RE: Chase Bank -1574 Woodbury Ave
TAC Comments

We are in receipt of an Application Review prepared by your office, dated March 3th, 2020. The following are responses to the previously mentioned comment letter:

DOCUMENT
SITE PLAN APPROVAL FOR CHASE BANK
SITE LOCATION
1574 WOODBURY AVENUE,
PORTSMOUTH, NH
03801

SHEET TITLE
DEMOLITION PLAN
JOB #: JPM 27086
DATE: 04/03/2020
SCALE: AS NOTED
DRAWN BY: DJR
CHECKED BY: AR
SHEET NO. **C-1**

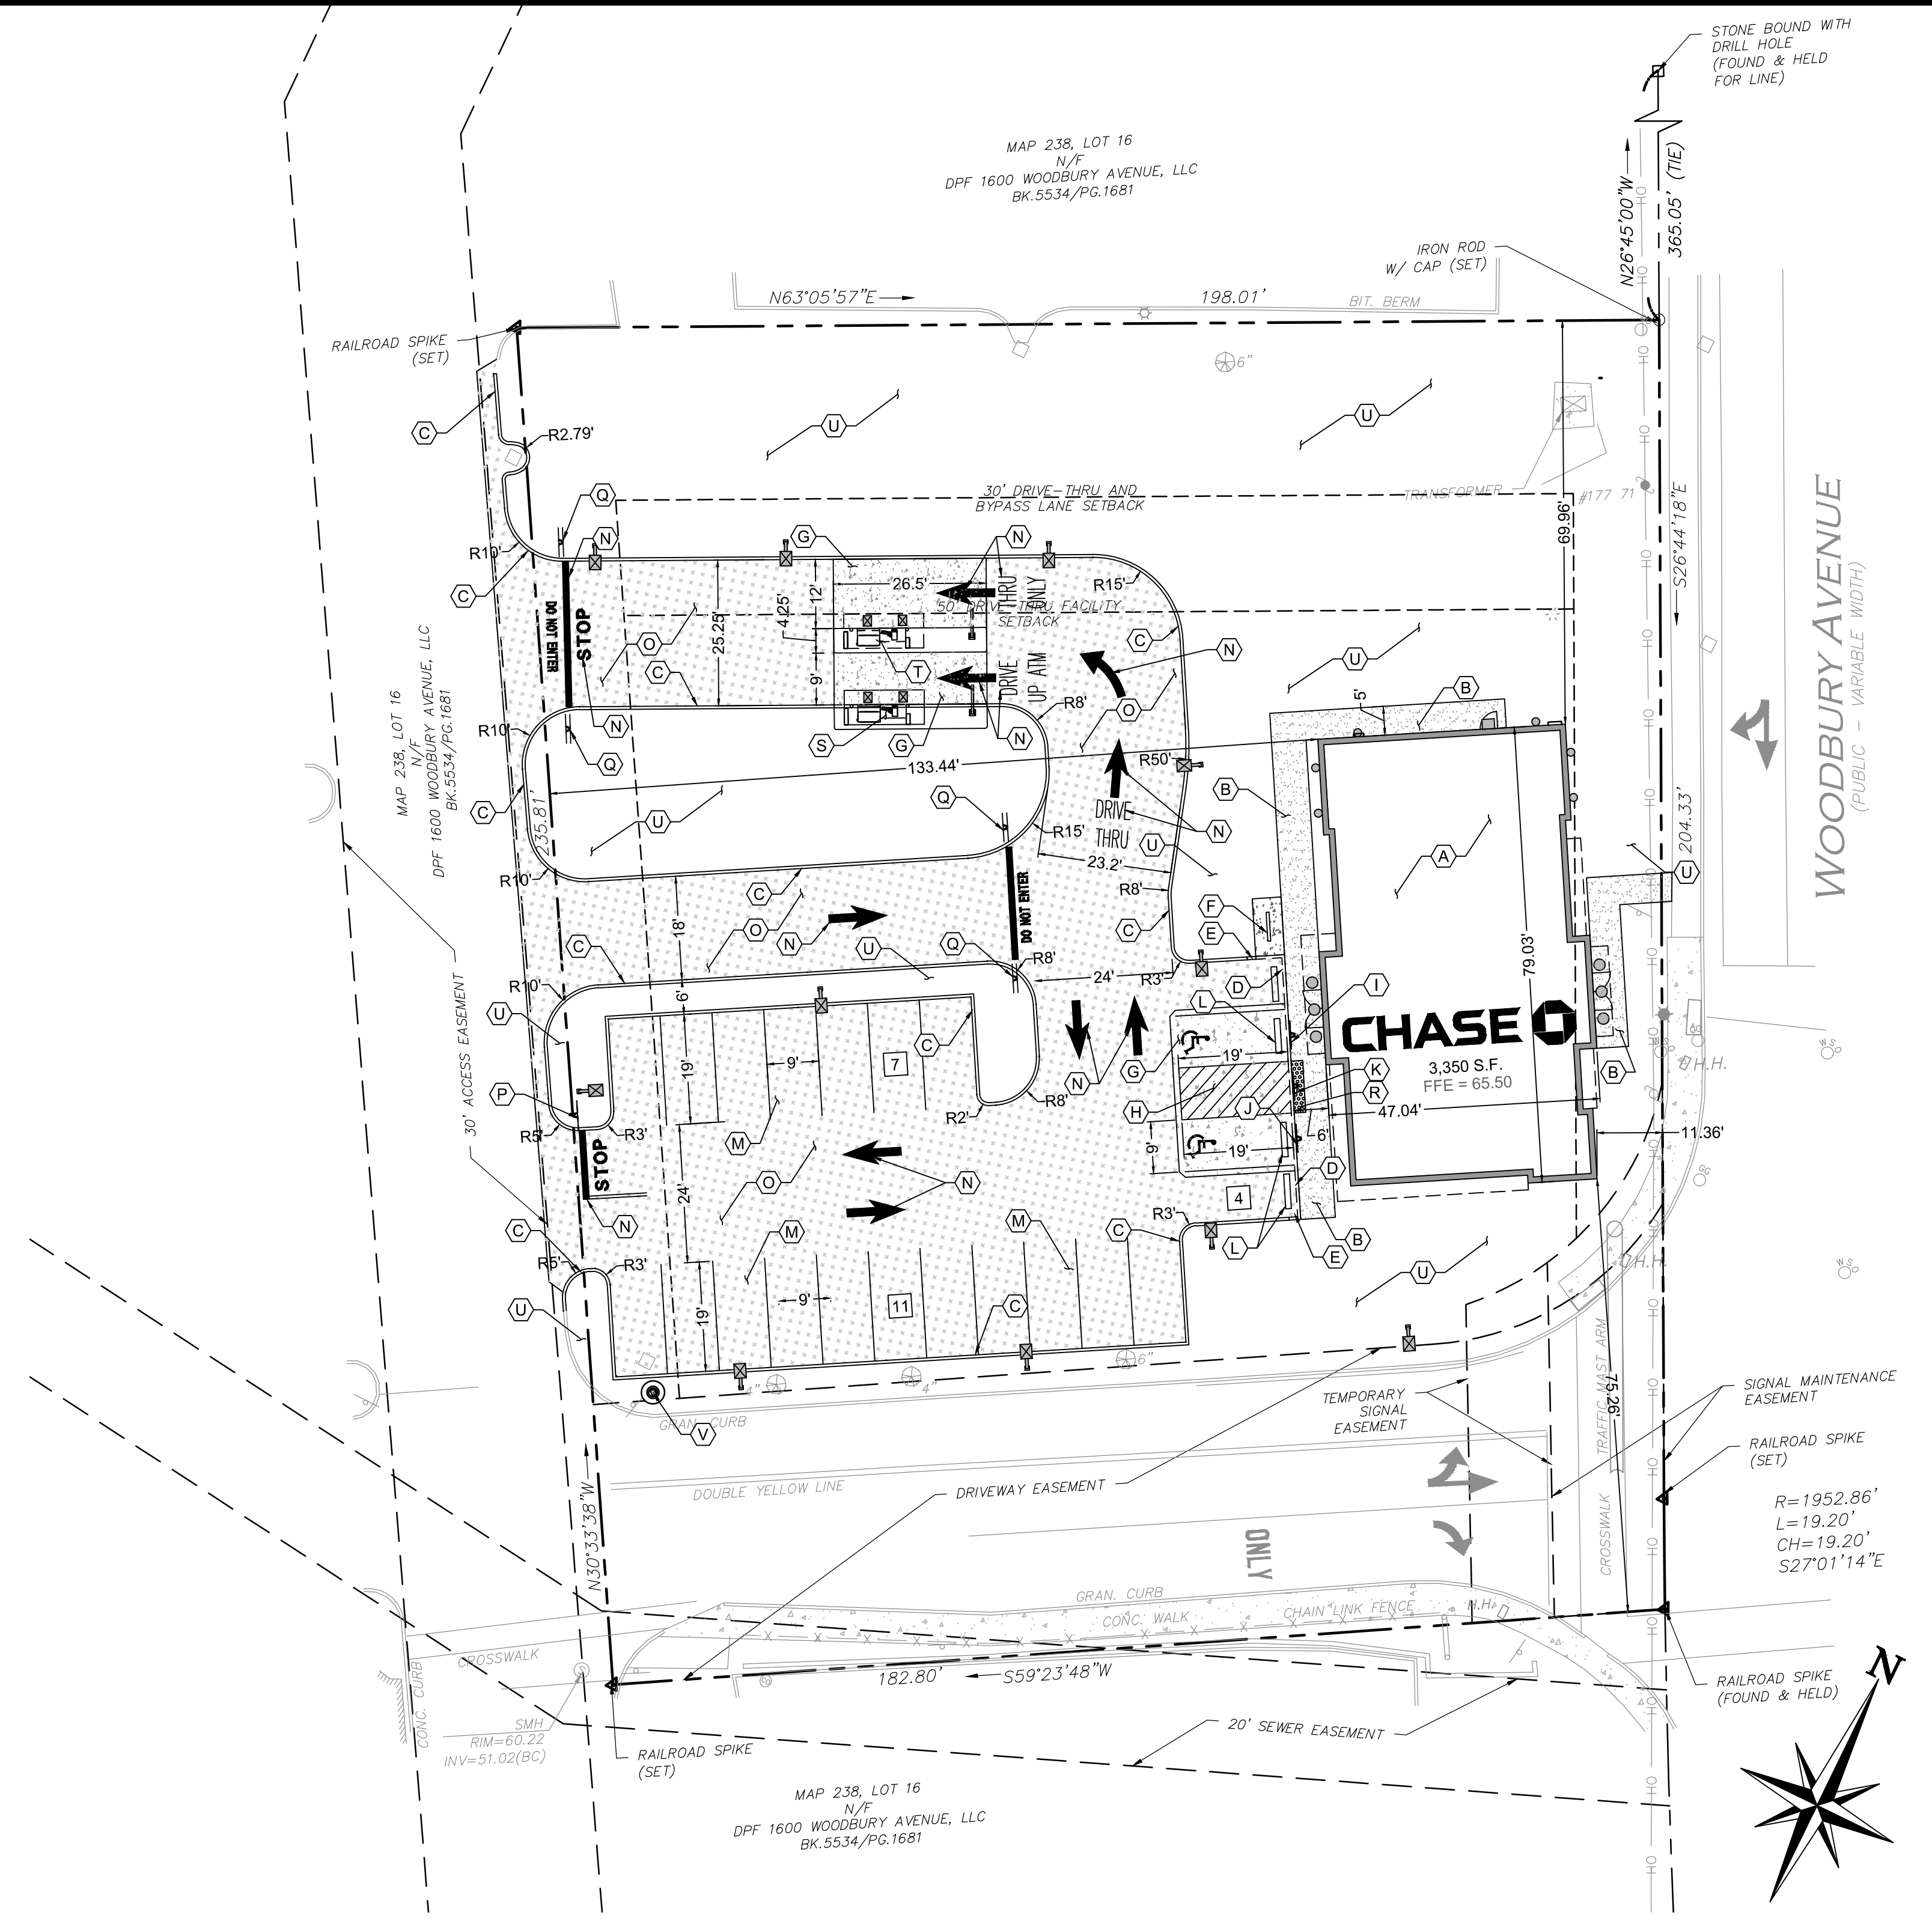
Comment 2 If the fire service is not being used, it will need to be abandoned out in Woodbury Ave and the City will require milling and repaving of the area as the pavement in the road is new.

Comment 3 The existing grease trap will need to be cleaned and then filled with sand.

- Comment 7** Is there a lighting plan?
- Response 7** A lighting plan has been added, see sheet C-8 & C-9.
- Comment 8** Storm drainage and sewer pipes not being reused should be either removed or flow-filled.

Response 2 **The proposed project will abandon the fire service at the main. A note has been provided on the demolition plan, see sheet C-1.**

Response 3 **A note has been added to ensure the grease trap is properly cleaned and filled per requirements, see sheet C-1.**

- Response 8** The storm drainage an sewer pipes notes have been revised, see sheet C-1.
- Comment 9** The drive up ATM should have a full bypass lane for any vehicle that needs to get out of the queue. If a driver mistakenly enters the drive-thru they need to be able to bypass any queued vehicles.

SHEET TITLE
SITE PLAN
JOB #: JPM 27086
DATE: 04/03/2020
SCALE: AS NOTED
DRAWN BY: DJR
CHECKED BY: AR
SHEET NO.
C-2

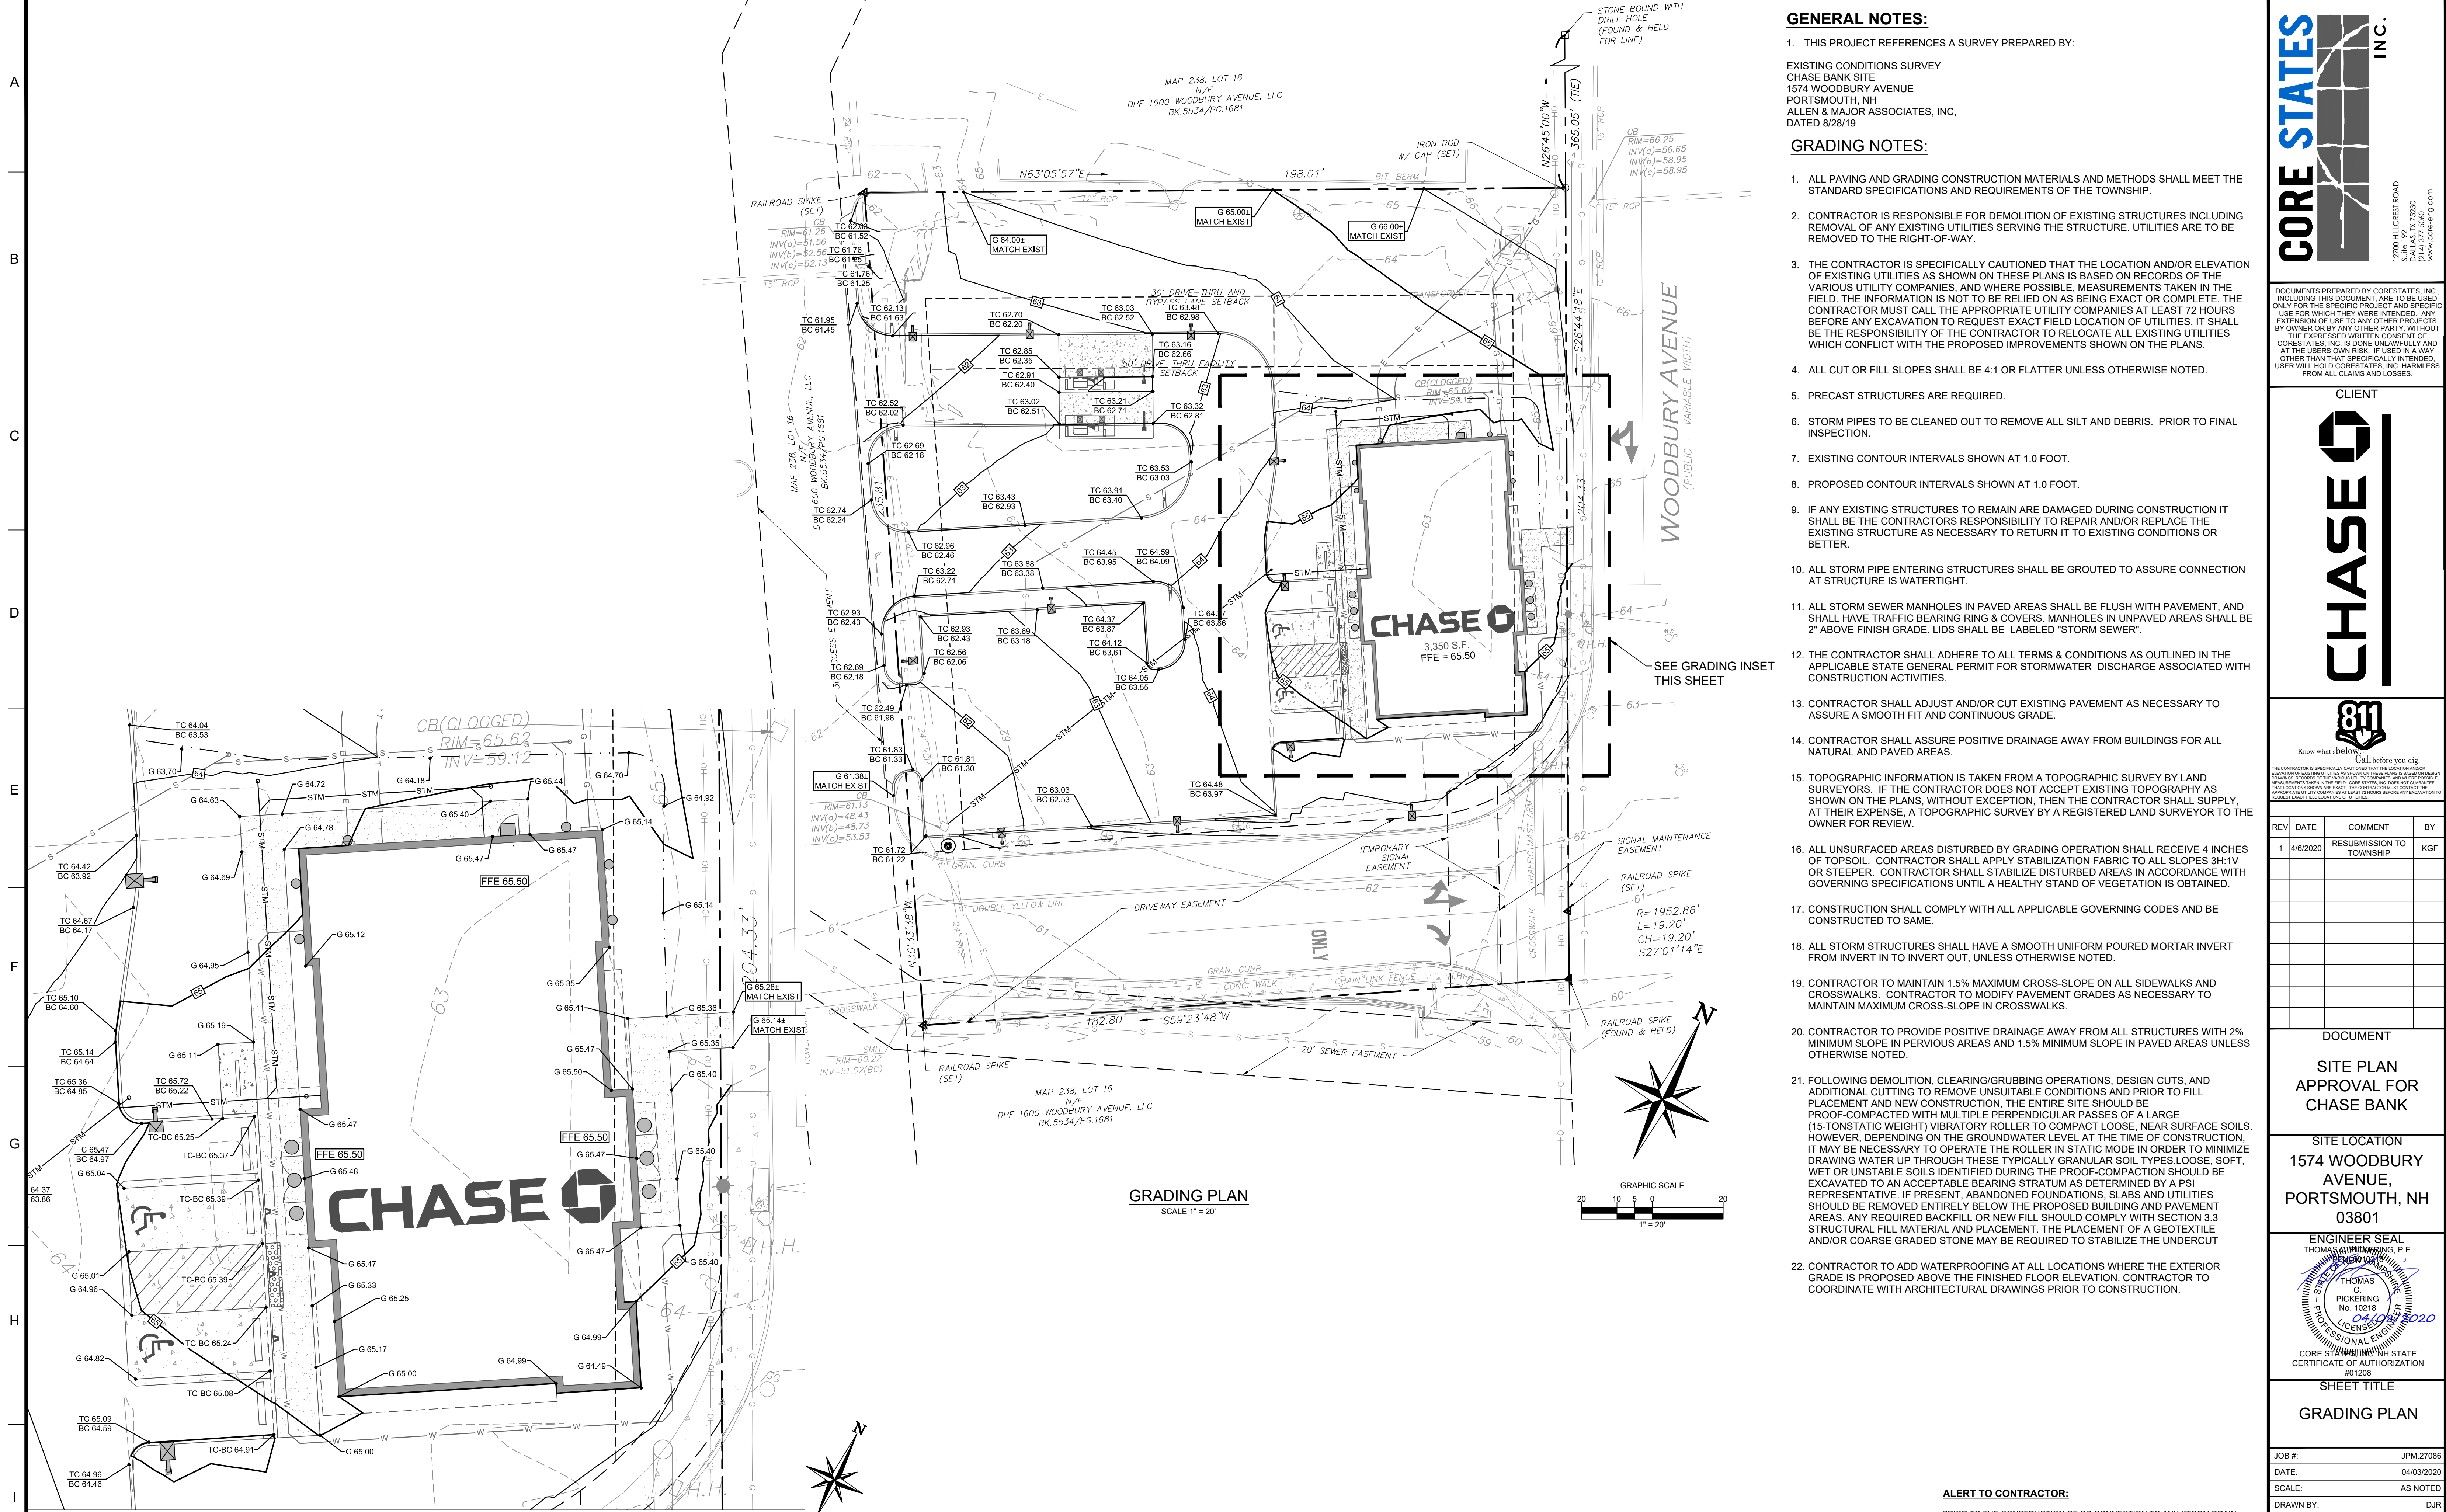
Comment 4 The parking stall at the end of a row of parking spaces should be made wider if possible to facilitate exiting the vehicle.

- Response 9** The site layout has been revised to address the issues, see sheet C-2.
- Comment 10** Parking lot aisles with more than 7 spaces should not be dead-ended. Drivers are not able to see if a space is empty or whether it is occupied by a smaller vehicle. Perhaps an outlet can be provided into the ATM bypass lane.

- Response 10** The site layout has been revised to address the issues, see sheet C-2.
- Comment 11** A NO PARKING sign should be provided at the head of the HP access aisle, if there is room between the walkway and the ATM drive lane.

Response 4 **The parking and site layout have been revised to address these issues, see sheet C-2.**

- Response 11** A No Parking sign has been added to the site plan see sheet C-2.
- Comment 12** A trip generation memo should be provided, comparing the proposed new bank use to the previous restaurant use.
